## PLAN COMMISSION REPORT

Proposal:	Plan Review – Multifamily Residential Buildings (A8.1 & A7.3)
Description:	Site, building, landscaping, and related review for two (2) proposed multifamily residential buildings in Lakeshore Commons.
Applicant(s):	E.J. Herr, F Street Development Group
Address(es):	4005 E. Lake Vista Parkway (4 <sup>th</sup> Aldermanic District)
<b>Suggested Motion:</b>	<p>That the Plan Commission approves the site and building plans submitted by E.J. Herr, F Street Development Group, for the A8.1 and A7.3 multifamily residential buildings on the property at 4005 E. Lake Vista Parkway with the following conditions:</p> <ol style="list-style-type: none"><li>1. That all relevant Code requirements and conditions of the Traditional Neighborhood Development Planned Unit Development (TND PUD) remain in effect.</li><li>2. That a contingent parking plan is provided for review and approval by the Department of Community Development prior to submission of building permit applications.</li><li>3. That the south elevation of building A7.3 incorporates façade enhancements similar to the other elevations.</li><li>4. That the screen wall on the south is revised to a height not

ARCHITECTURAL SITE PLAN  
1" = 20'-0"

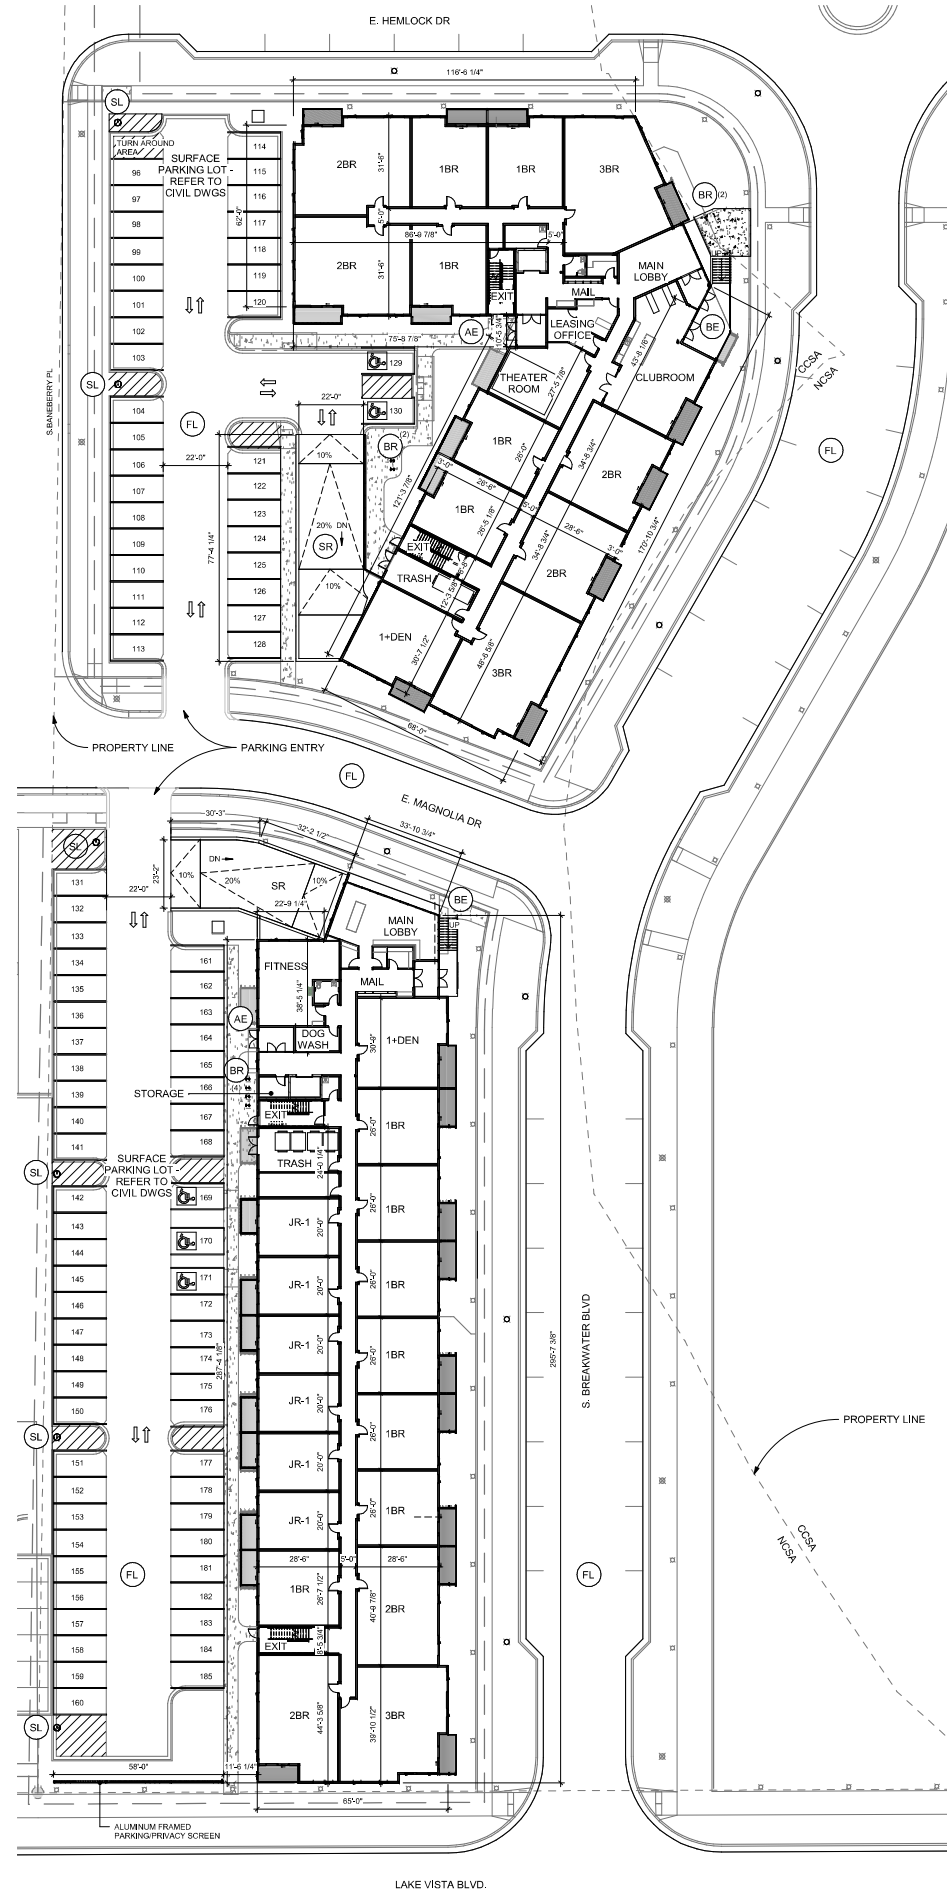
required for the north building and 108 for the south building. The concept plan as proposed provides a total of 185 dedicated stalls between the two buildings, which is just short of the minimum requirement of 188. As presented, the total of 185 dedicated stalls would equate to less than one parking stall (185) per bedroom (197). This is concerning, especially given the limited availability and seasonality of public on-street parking, the already-reduced parking ratios for this development and the inclusion of dens (which may be used as an additional bedroom) in 11 of the units.

Bicycle storage areas are identified in three (3) areas of the north underground parking structure and one (1) area of the south underground parking structure per PUD requirements. Bicycle racks at entries to the buildings are also shown. It should be noted that the PUD requires that a contingent parking plan to be provided identifying areas for future parking should actual demands exceed minimum requirements. As of writing this report, a contingent parking plan has not been provided.
